July 2, 2025 AEC 24-153

Re: Environment Impact Study Addendum #1 for a Proposed Development on Part of Lot 40, Concession 8 (The Gateway Centre), Town of Collingwood

The purpose of this EIS Addendum is to outline additional study undertaken related to the documentation of bat "snag" trees on and adjacent to the property, with potential to provide day or maternity roosting habitat for bat species, and to respond to NRSI and NVCA natural heritage peer review comments. Detailed peer review comments included in *Table 1. NRSI Peer Review Comments on Environmental Impact Study (Azimuth 2024)* of NRSI's December 2024 letter are attached to this EIS Addendum for reference, to which responses are provided on an individual basis below. Azimuth's response to NRSI Peer Review Comment #6 is combined with Azimuth's response to NVCA's EIS comments issued through the March 2025 review letter.

Figure 2 – Environmental Features (Updated)

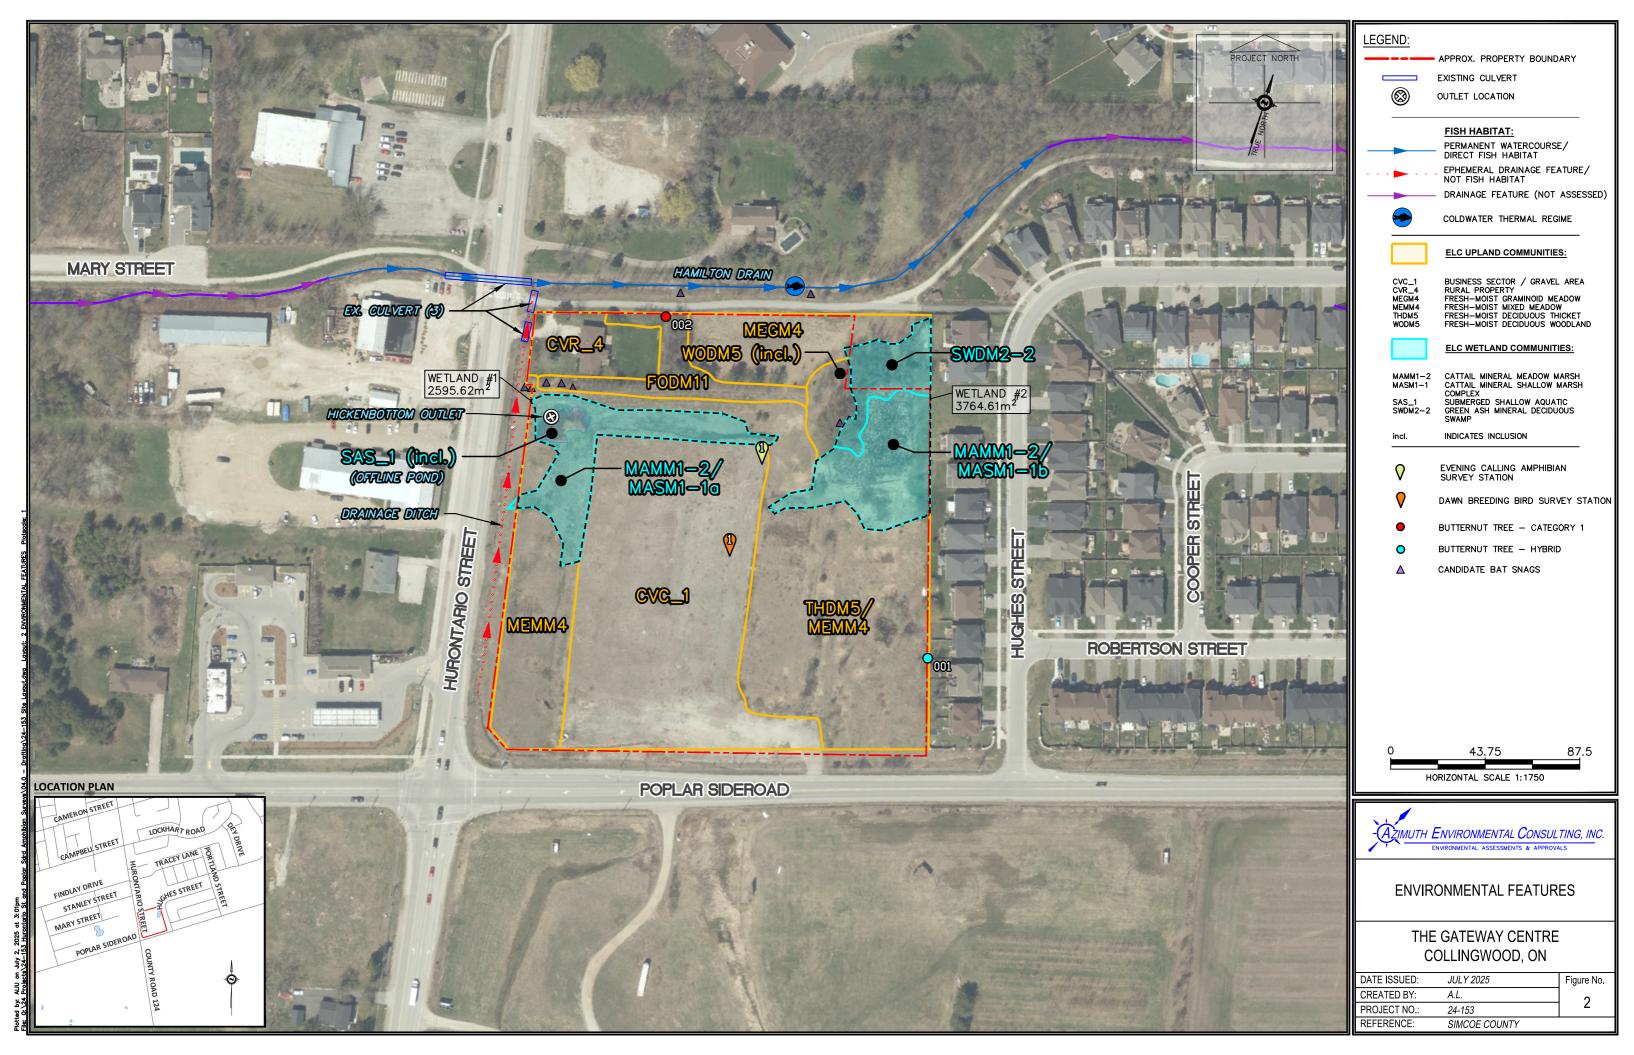
3	Section 4.7 Significant Wildlife Habitat (pg.17) and Table 5 Significant Wildlife Habitat Criteria Schedule for Ecoregion 6E (pg.3 of 17)	Table 5 provides the results of the Significant Wildlife Habitat screening for the subject property. Under the wildlife habitat section for "Bat Maternity Colonies", it is stated that a SWD Ecosite is present within the subject property. This Ecosite is considered eligible to support bat maternity SWH. However, the SWH screening table within the EIS states that this Ecosite is too small to be considered a standalone vegetation community and not anticipated to be of sufficient maturity to support bat maternity SWH. Under strict guidelines of the Ecoregion Criteria Schedule for 6E, there is no minimum habitat size criteria for bat maternity SWH Candidate habitat is determined by FOD, FOM, SWD and SWM stands with >10/ha large diameter (>25cm DBH) wildlife trees. It is recommended that the screening table be revised to remove any reference to the size of the SWD community in reference to the potential absence or presence of SWH. The assessment of potential SWH should be informed by the completion of field surveys examining whether or not the Ecosite contains the

Comment #	EIS Section	NRSI Peer Review Comment	Response
		minimum density (>10/ha) of wildlife large diameter trees (>25cm DBH). It is understood that habitat surveys were conducted during leaf-on conditions. While it is noted these surveys were conducted outside of suitable conditions, it is anticipated that the previously conducted field surveys should allow for the identification of Candidate Bat Maternity SWH. Should candidate habitat be determined to be present, Section 4.7 is to be updated.	
4	Section 7.1 Habitat for Threatened or Endangered Species (pg.19-21)	NRSI staff agree that the EIS is to account for Species at Risk Bats including, Little Brown Myotis, Northern Myotis, Tri-colored Bat. The EIS states that trees >25cm DBH within woodlands may provide maternity roosting habitats to SAR bats and later states that "Trees of any size with suitable opportunities for bat access may also be utilized for day roosting purposes during the remainder of the active period." NRSI staff disagree with this characterization of habitat use. As per the technical document referenced by Azimuth within this section (<i>Bat Survey Standards Note (MECP, 2022)</i>), there are numerous peer-reviewed publications identifying that trees measuring less than 25cm DBH may support both maternity and day roosts of Little Brown Myotis, Northern Myotis and Tri-colored Bat. As a result, this statement is incorrect. It is recommended that the SAR section of the EIS be revised to remove or update this statement to appropriately identify that trees <25cm DBH may support both day and maternity roosting habitat.

The locations of snag trees documented during the bat snag inventory exercise are illustrated on an updated version of Figure 2 (attached), noting that given the immature/recently disturbed state of the property only eight (8) snag trees were identified, four (4) of which were present on the property, two (2) within the Hurontario Street right-of-way, and the remaining two (2) beyond northern property boundary along the axis of the Hamilton Drain. None of the identified snag trees exhibited high quality features for bat access such as large hollows/holes, rather provided more marginal bat habitat characteristics such as dead limbs/branches and loose bark.

The SWD ecosite on the subject property measures 0.13 hectares (ha) in size and contains one (1) snag tree exceeding 25cm DBH (see updated Figure 2, attached), or, a snag density of 7.69 snags/ha. According to the Ecoregion 6E Criteria Schedules (MNRF, 2015) for the Significant Wildlife Habitat Technical Guide (OMNR, 2000), the minimum snag density for a qualifying ecosite to be considered as potential Bat Maternity Colonies is 10 snags/ha. As such, the SWDM2-2 unit in the northeast corner of the property (extending off-property) does not meet the minimum snag density criterion for further consideration as Significant Wildlife Habitat (SWH) for Bat Maternity Colonies.

Figure 3 – Proposed Development (Updated)

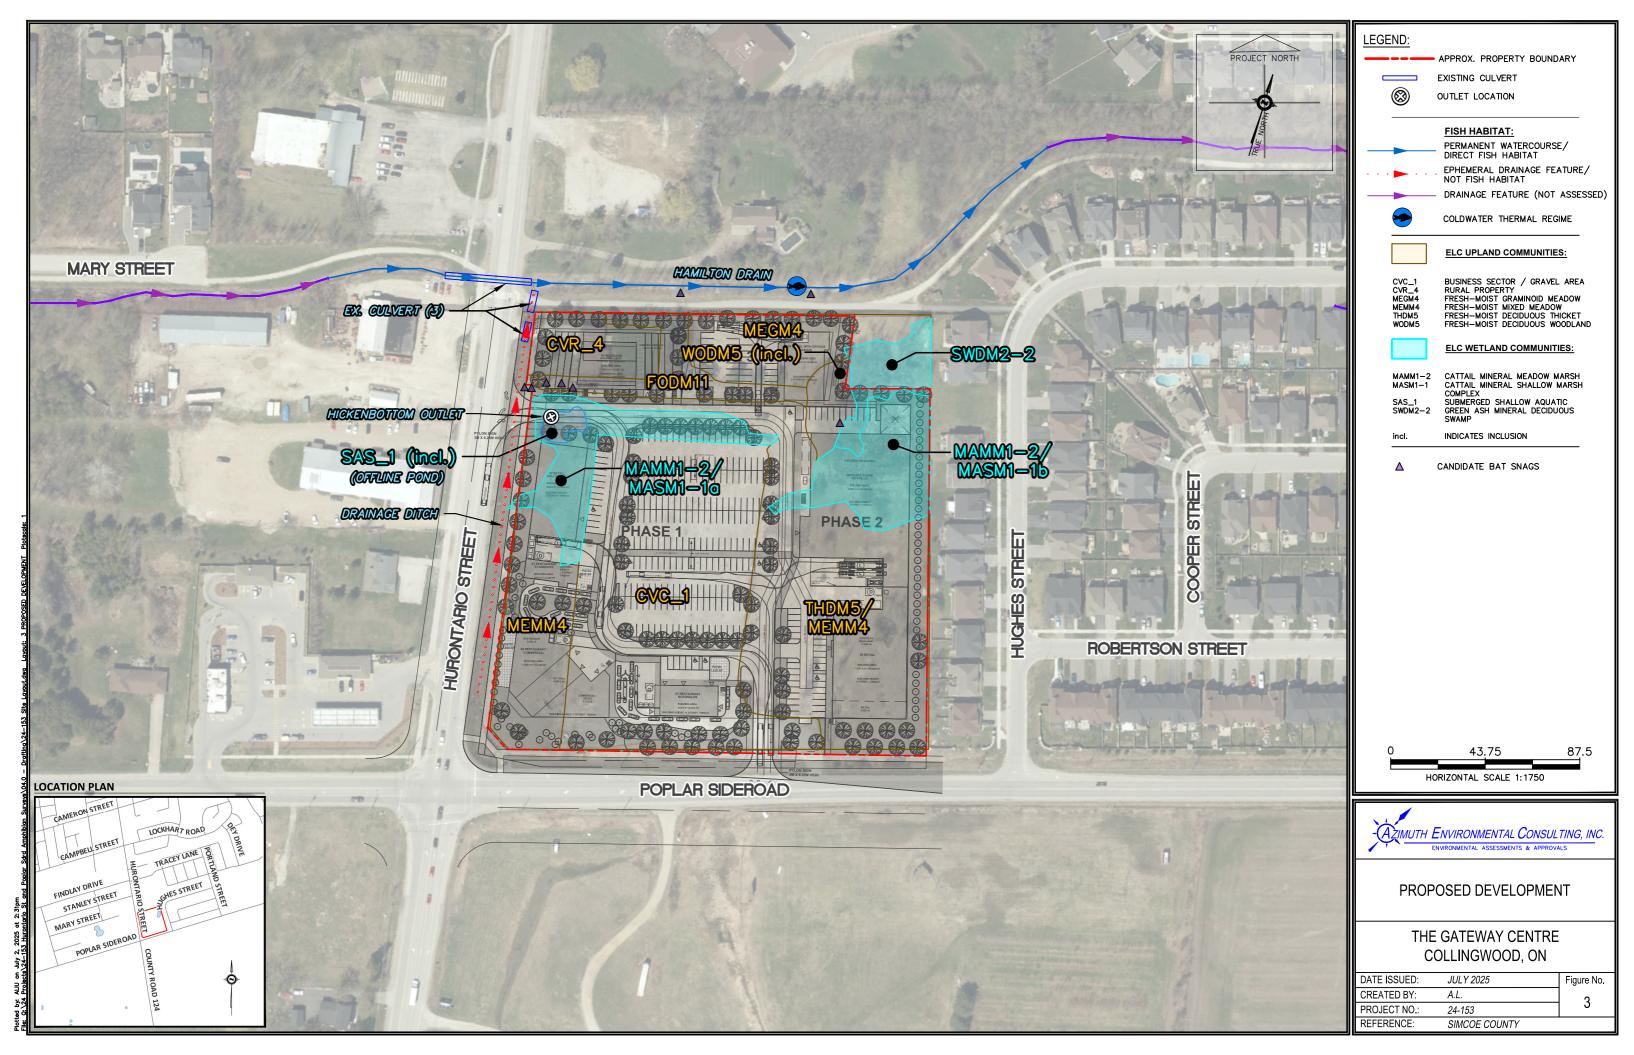
NRSI staff also disagree with the use of the incomplete quote from the Bat Survey Standards Note (MECP 2021), as the quote referenced within the EIS omits an important detail that is required to understand suitable habitat availability and potential impacts.	
		It is recommended that the full quote is provided within the EIS. As per the Bat Survey Standards Note, If a proposed activity will avoid impairing or eliminating the function of habitat for supporting bat life processes (e.g. remove, stub, etc. a proportionally small number of potential maternity or day roost trees in treed habitats which would not result in fragmentation or barriers) and the timing of tree removal will avoid the bat active season (April 1 – September 30 in Southern Ontario / May 1 to August 31 in Northern Ontario), then there is no need to conduct SAR bat surveys of treed habitats.	
		In order for this exemption to be applicable, the author needs to determine whether or not the removal of subject property treed habitat for development will fragment the habitat and/or create habitat barriers, particularly since leaf-off habitat surveys were not conducted. Should the EIS effectively demonstrate that the development will not fragment habitat or create habitat barrier, NRSI staff generally agree that that avoiding vegetation removal during the bat active period is a suitable approach to avoid harm to individuals of the species and thereby avoid contravention of Section 9 of the Endangered Species Act. It is noted that this section identifies that the "proposed works involving removal of a small number of immature snag trees" would not result in an impact to SAR bats or their habitat. No data or mapping to illustrate the number of snag trees proposed for removal has been provided and leaf-off surveys have not been completed. While it is understood that the majority of potential roosting trees are limited to immature Green Ash impacted by Emerald Ash Borer, the

Comment #	EIS Section	NRSI Peer Review Comment	Response
		specific number of potential habitat tree should be identified in order to support the conclusion that only a "relatively small number" of potential habitat trees will be removed. This assessment should consider that trees smaller than 25cm DBH may provide maternity roosting habitat and declining Ash trees are known to provide suitable roosting features.	
		The EIS has offered that "the proposed development would retain similar wooded areas directly north of the property boundarieswhich would provide potential day roosting function for bats in the post-development setting". The preservation of existing off-site features on lands not owned by the applicant cannot be used to rationalize the avoidance of impacts to the form of function of features within the subject property. Further, it appears that no assessment or characterization of the wooded features north of the property has been completed by the Azimuth. As a result, no evidence has been provided to support the claim that day roosting is occurring within these areas. This section of the EIS should be revised. It is also recommended that the EIS (or addendum) include discussion on the proposed Landscape Plan and plantings as they relate to the mitigation and offsetting of the removal of treed habitats.

Based upon additional bat habitat study undertaken in April 2024 described above, the following augmented assessment is provided with regard for potential impacts to SAR bats. An updated Figure

3 (Proposed Development) is attached, illustrating the locations of documented snag trees relative to the proposed development limits.

The proposed development will require the removal of six (6) candidate bat habitat trees for SAR bats, all of which are characterized as **low quality** snag features, with potential opportunities for bat access limited to dead limbs/branches and loose bark. Five (5) of the snag trees in the western portion of the property/Hurontario Street right-of-way were identified as Green Ash (*Fraxinus pennsylvanica*) stems ranging 18-27cm DBH in the early-mid stages of decay, and due to evidence of Emerald Ash Borer (EAB) disease are unlikely to provide supporting leaf cover. Given their decaying condition due to EAB disease, it is likely that the described Green Ash will continue to decline and will fall or potentially require removal (if deemed hazards) independent of this application process.

Figure 4 – Proposed Wetland Removals

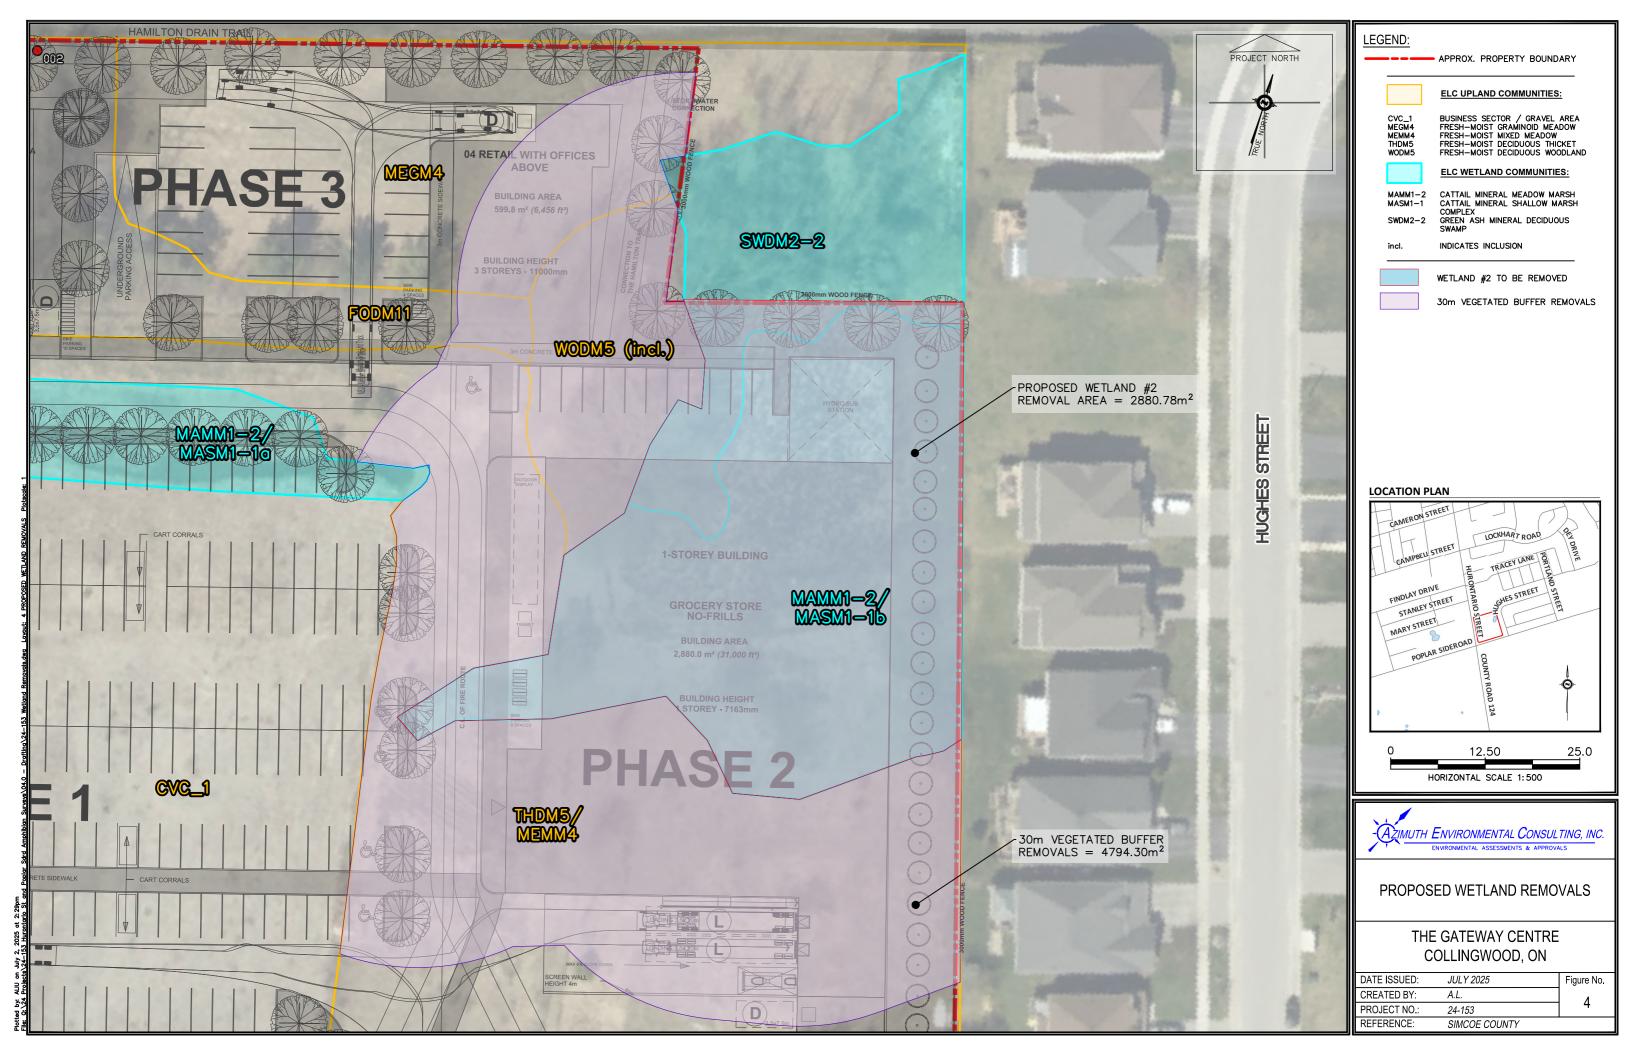
- 6. The EIS notes that 0.39ha of the east wetland feature is proposed to be removed and that following completion of the groundwater monitoring, an addendum will be issued with the applicants proposed offsetting strategy. NVCA staff look forward to reviewing the proposed compensation plan which will be required to support the proposed development.

O.Reg. 41/24. As such, NVCA permitting is required for the removal of 2,881m² of Wetland #2 and
associated 30m vegetated buffer measuring 4,289m². A new Figure 4 (Proposed Wetland Removals)
is attached, illustrating the area of proposed wetland and 30m vegetated buffer removals associated
with Wetland #2.

Based on the above review, it is Azimuth's opinion the proposed development would be considered eligible for wetland compensation (under Step 4) as outlined in the Offsetting Guidelines. As described above, the quantity of area loss is equal to 2,881m² and the quantity of wetland setback loss (i.e. upland areas within 30m of the wetland edge) is equal to 4,829m². Section 3.2 of the Offsetting Guidelines specifies that a wetland replacement ratio of 2:1 should be implemented for direct wetland losses, and a wetland replacement ratio of 1:1 should be implemented for loss of wetland setback, therefore based on the proposed wetland vegetation removals, the required wetland compensation to achieve ecological gains would be 10,591m² ((2,881m²*2) + 4,829m²).

With regard for the above, it is Azimuth's opinion that removal of 2,881m² within Wetland #2 in addition to 4,829m² of the supporting upland 30m vegetated buffer (Figure 3) is eligible for wetland compensation in accordance with NVCA's Offsetting Guidelines, and that payment of \$127,092.00 toward NVCA implementation of wetland creation/restoration projects would achieve a net gain for the proposed wetland losses. As such, with consideration for mitigation and compensation detailed in the initial EIS submission and additional information presented above, there is no expectation that the proposed works would negatively impact Other Wetlands within the study area limits.
